ADDENDUM NO. 1

RFQ CCC-078

**Administration Building Renovation
Compton Community College District**

tBP Project. No. 20987.00

3. **Revised SHEET A0-2 REFLECTED CEILING PLAN DEMOLITION**

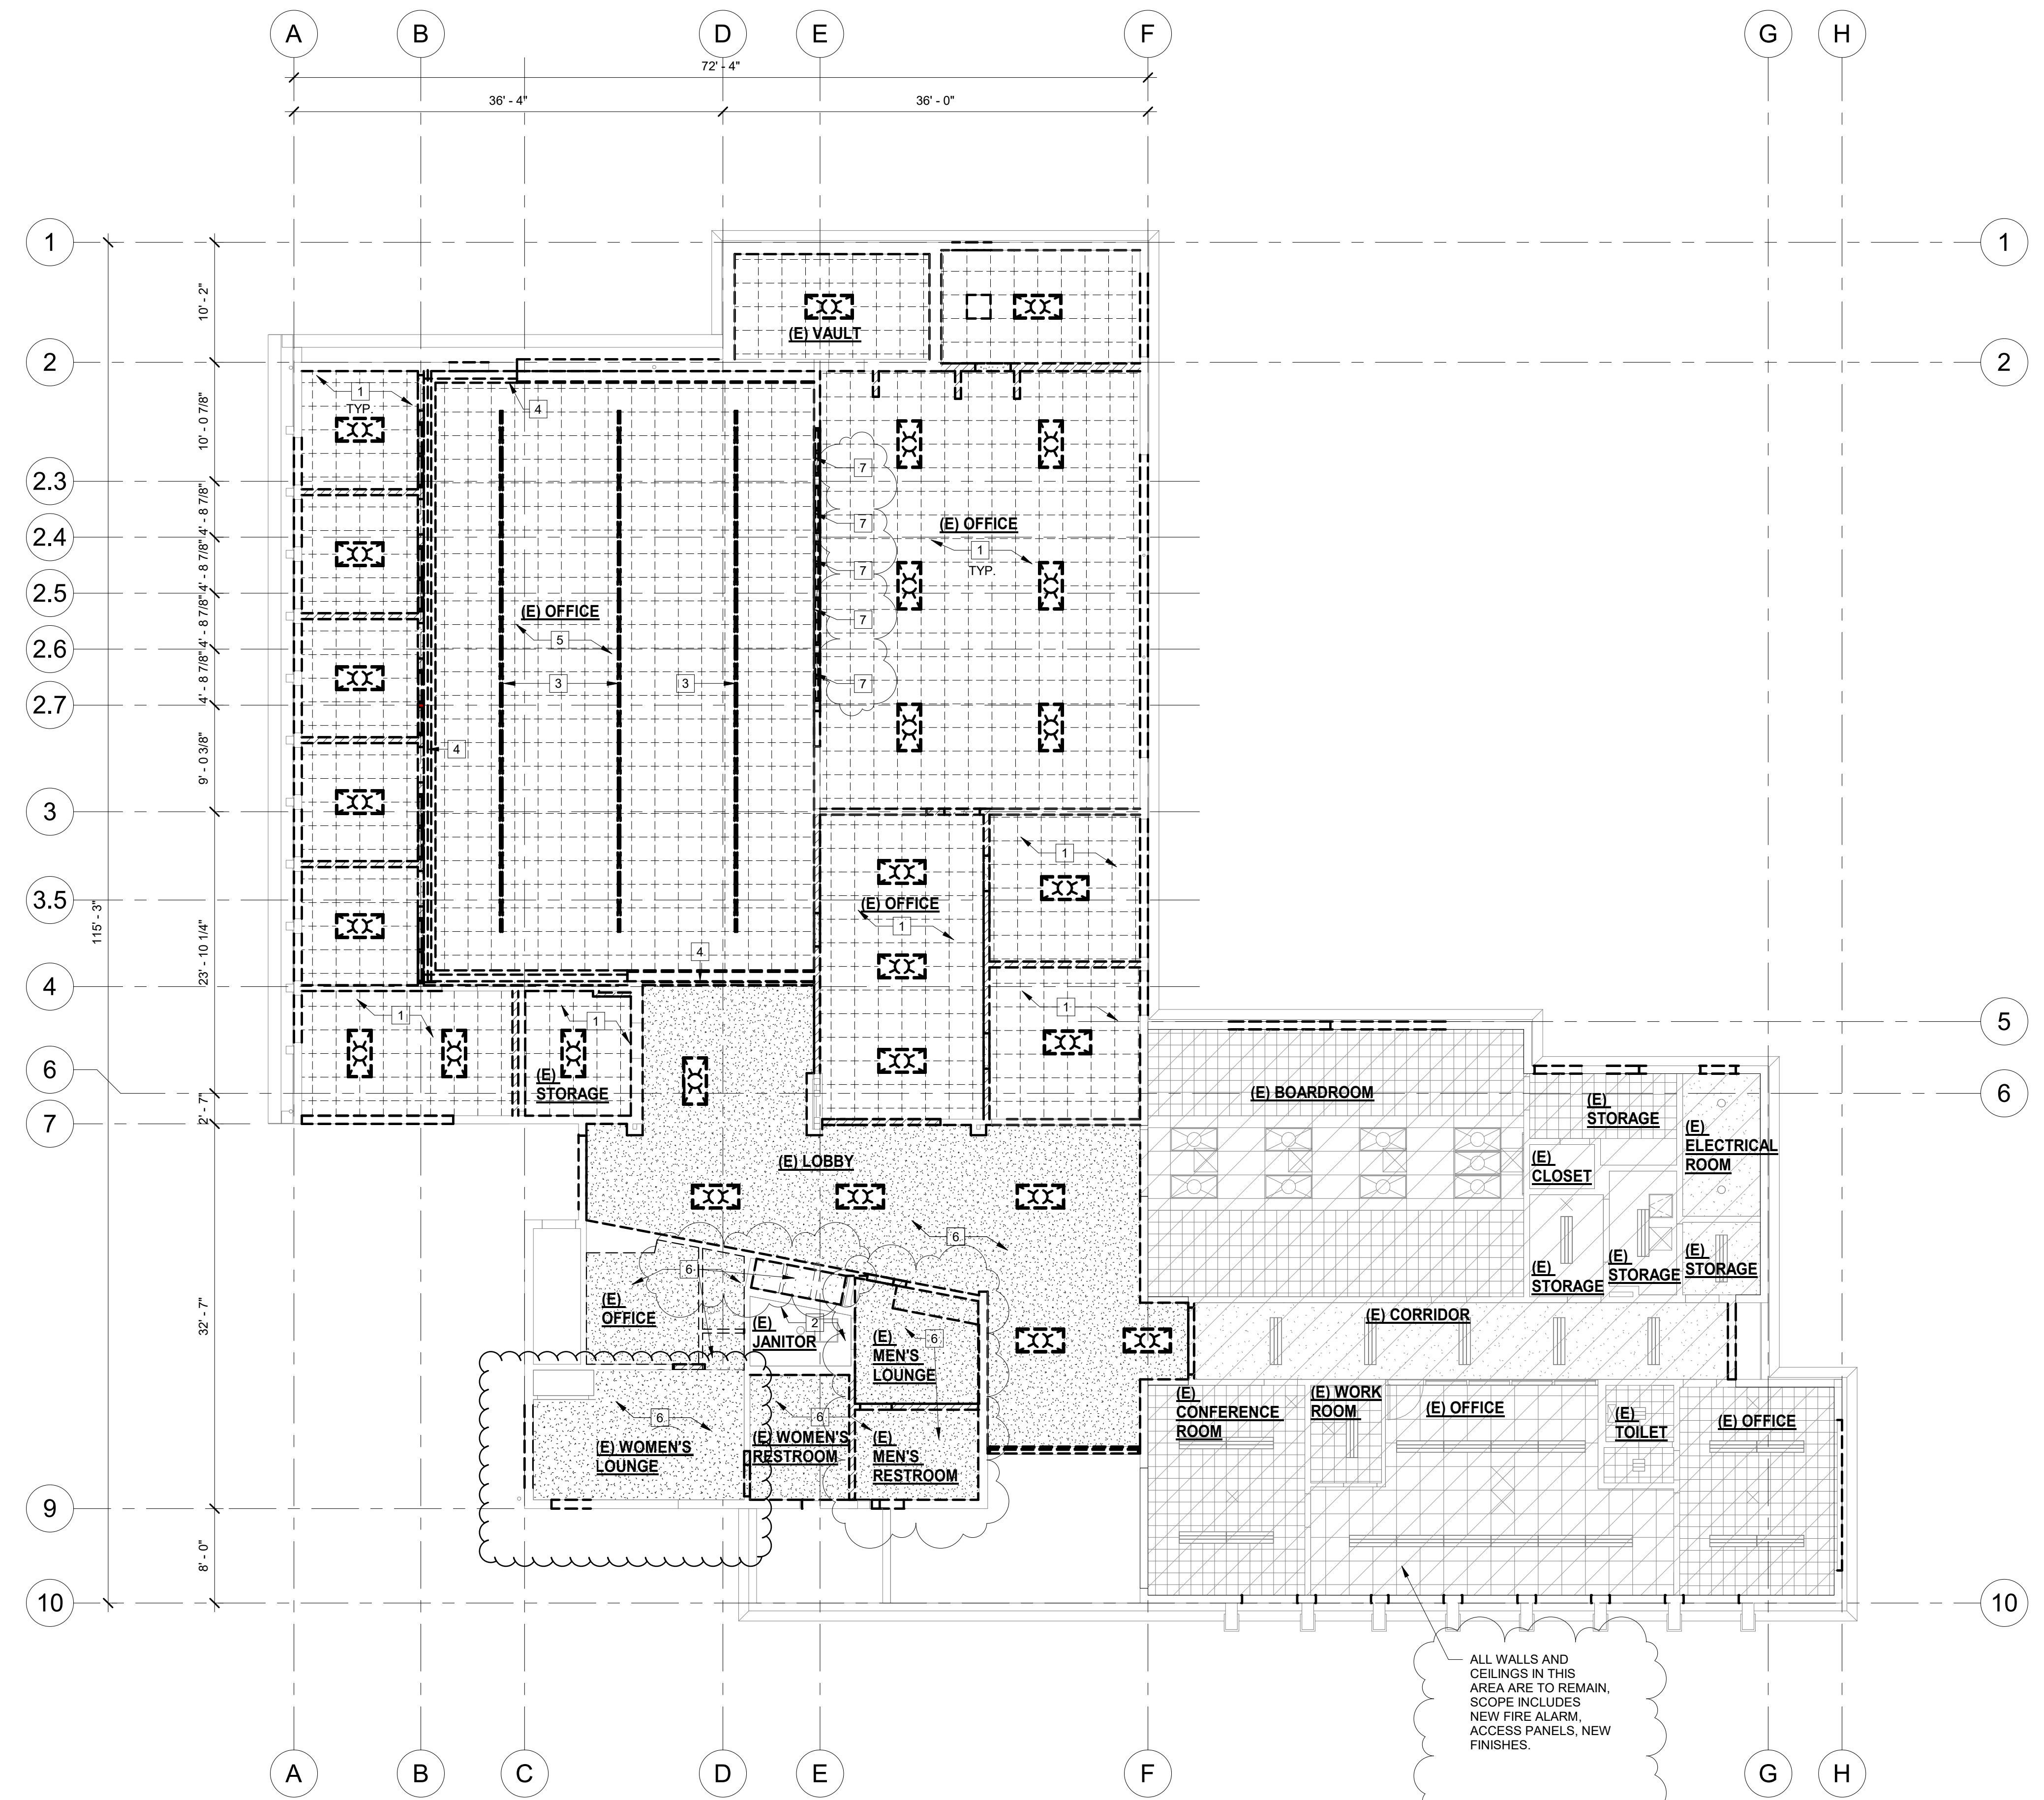
- a. Corrected general notes to clarify ambiguous scope notes.
- b. Added ceiling demo scope where walls are removed in Restrooms.
- c. Added the demolition of the original building phone booths.
- d. Identified and noted area of new access panels for fire alarm upgrade to President's office area.
- e. Clarified ceiling to be removed at Women's Lounge room.
- f. Reworded demo notes 1, 5 and 7.
See attached revised Full size sheet identifying revisions included as part of this addendum.

5. **Revised SHEET A1-1 FLOOR PLAN RENOVATION**

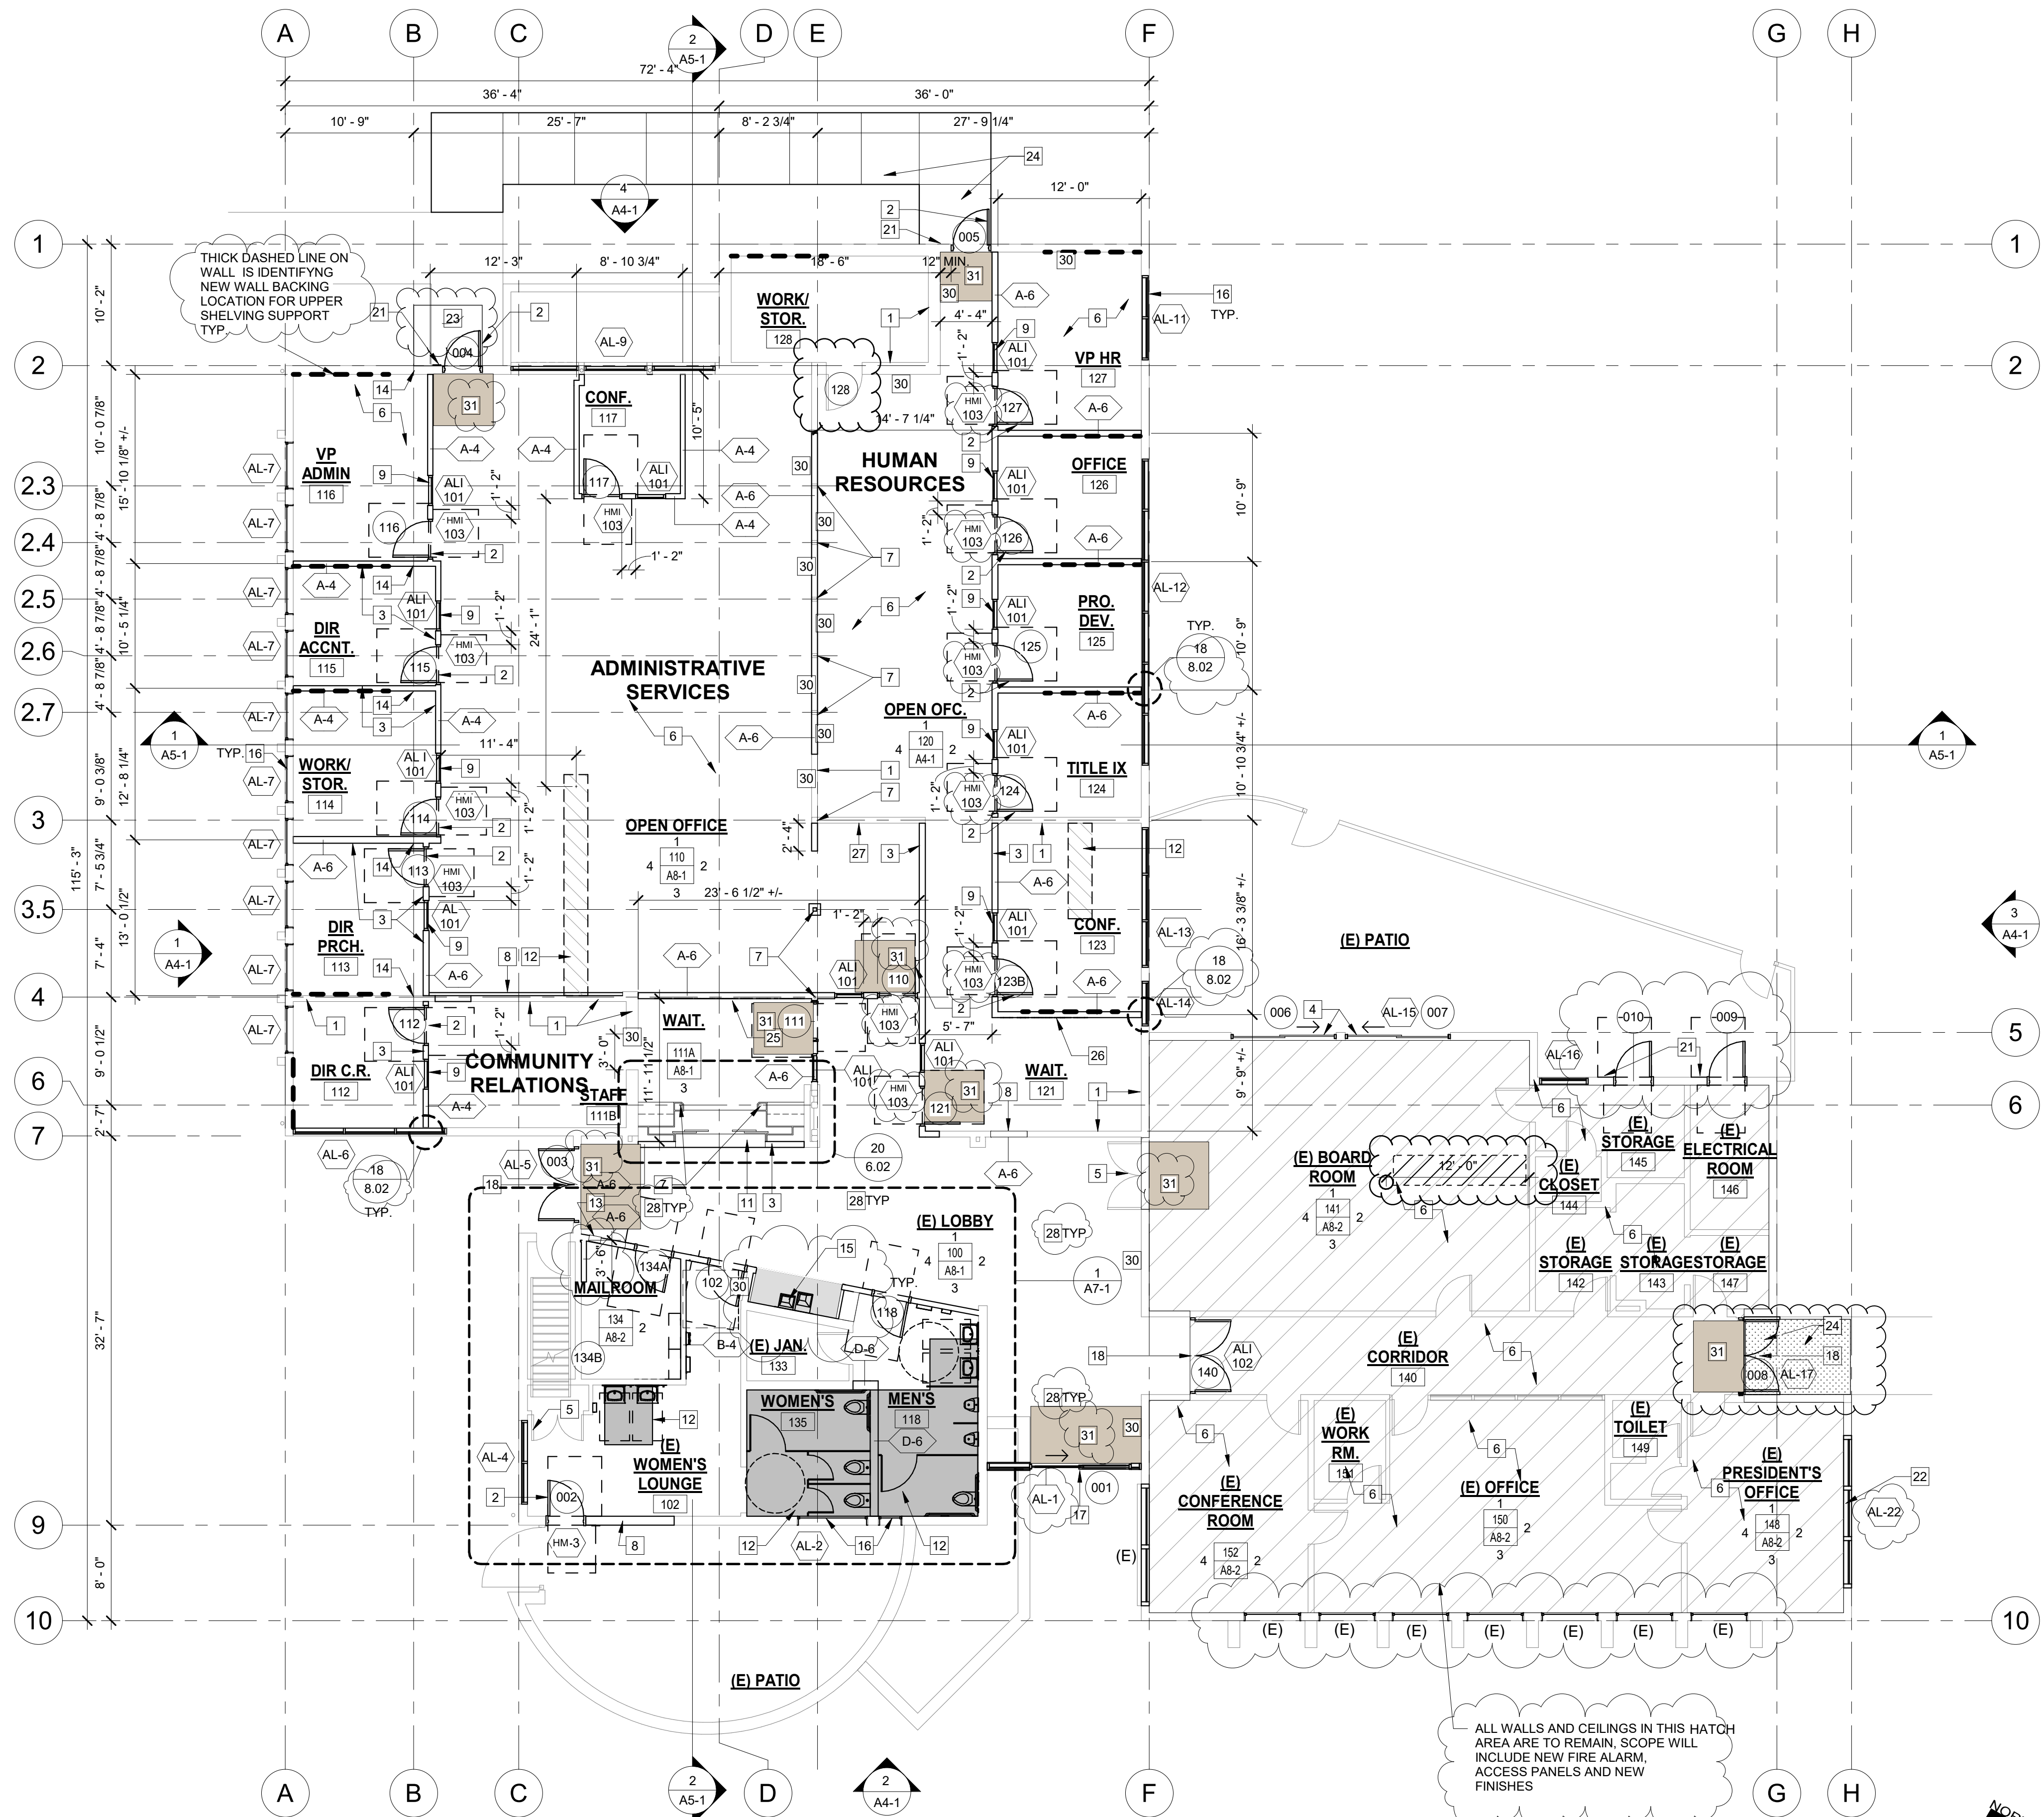
- a. Corrected general notes and key notes to clarify ambiguous scope notes.
- b. Added two new doors to scope at Electrical Room 146 and Storage 145.
- c. Corrected wrong detail reference at ext. window at grid line "F" and at gridline "7".
- d. Relocated new high/Low drinking fountain to alcove where the telephone booths are being removed.
- e. Added 6" furring wall at Mailroom 134 for Electrical panel re-location.

- f. Added new window AL-22 to the scope.
- g. Added keynotes reference and notes #s 22, 23, 24, 28,31
- h. Interior wood doors' frame to be Hallow Metal instead aluminum.
- i. Lobby floor to be patched and prepared to receive new finish.
- j. Added door 128 to the hardware scope.
- k. Identified backing in wall for shelves and cabinets.
- l. Removed 7 windows from scope at south elevation of the building.
See attached revised Full size sheet identifying revisions included as part of this addendum.
